Use Permit Application

Application Type: WINERY USE PERMIT (NEW)

Project Name: Krupp Brothers Winery

SUBJECT: PROJECT REVISION MATERIAS FOR KRUPP BROS. WINERY

KRUPP BROTHERS WINERY
 CREEK ENCROACHMENT EXHIBIT
 NAPA COUNTY CALIFORNIA

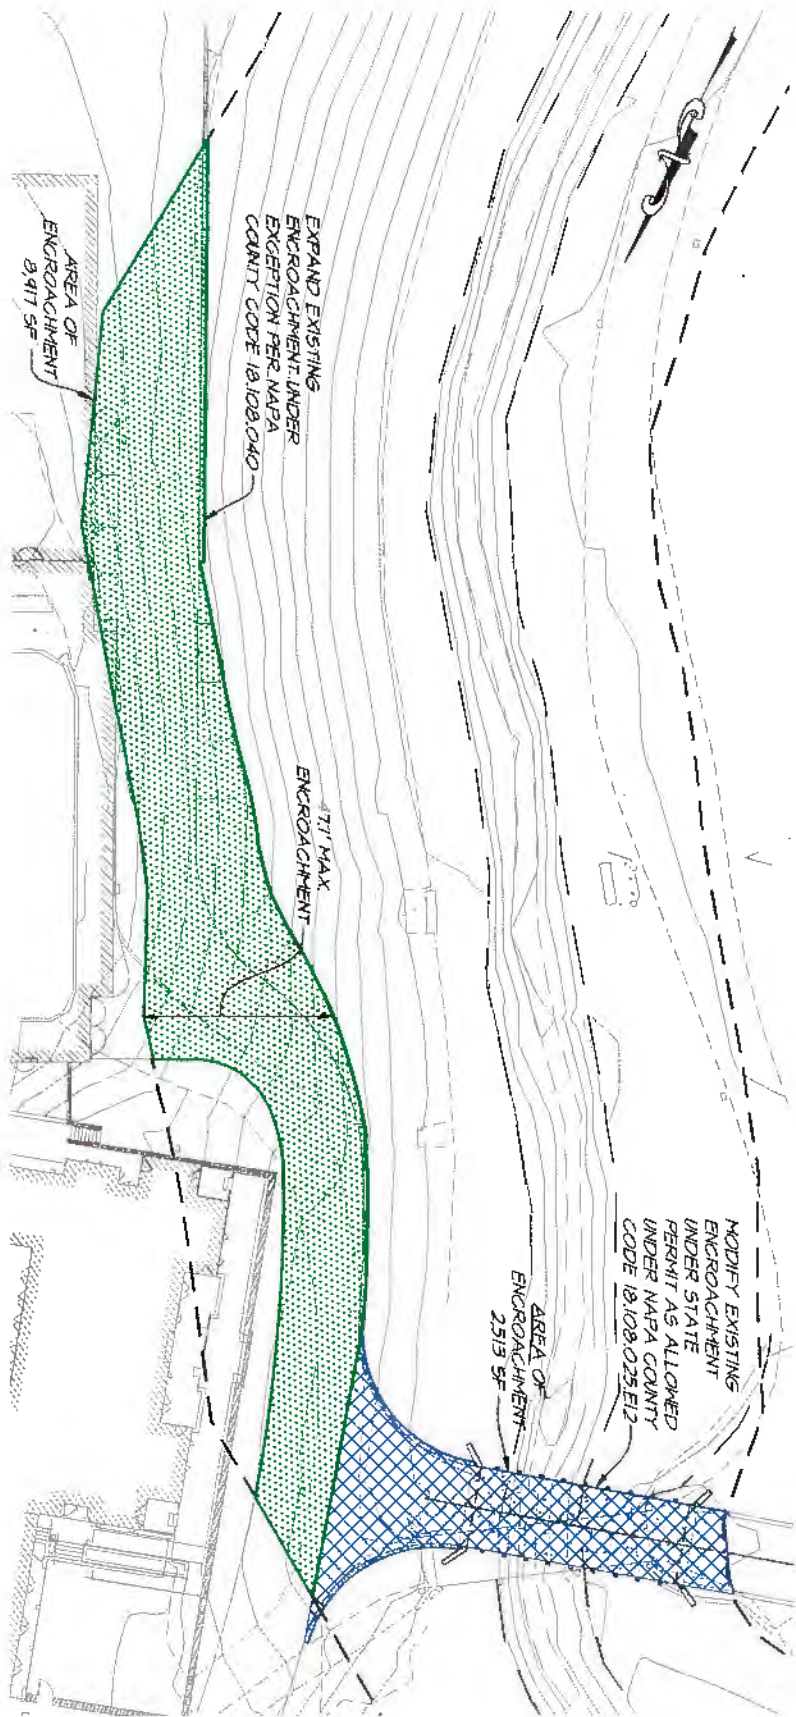
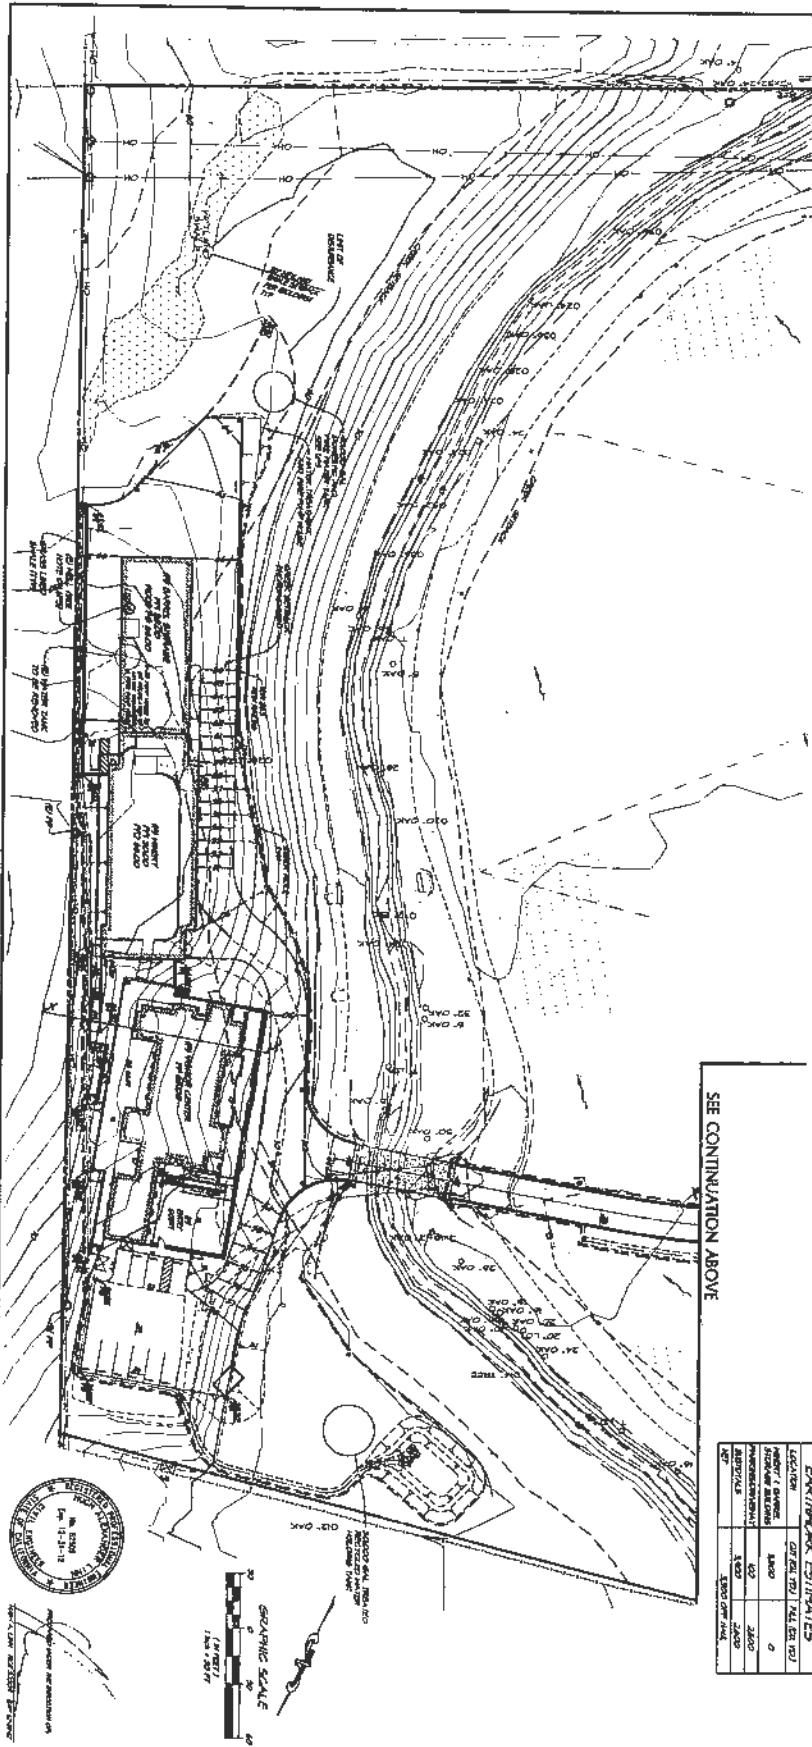
The proposed encroachment into the creek setback is a total of approximately 8,917 square feet; this is 47 feet within the stream setback, for a length of about 50 feet. The encroachment area and the proposal for the exception is illustrated in the enclosed revised site plans. The encroachment area is of sufficient distance from the creek, due to the method of calculating setback via the 35-ft. minimum distance plus an allowance for slope differential, that mitigation measures to minimize potential sedimentation into the creek should be very effective. The effectiveness of these measures, including a wall between the winery access road and the creek, has been part of the evaluation of Dr. Chris Kjeldsen, the biologist.
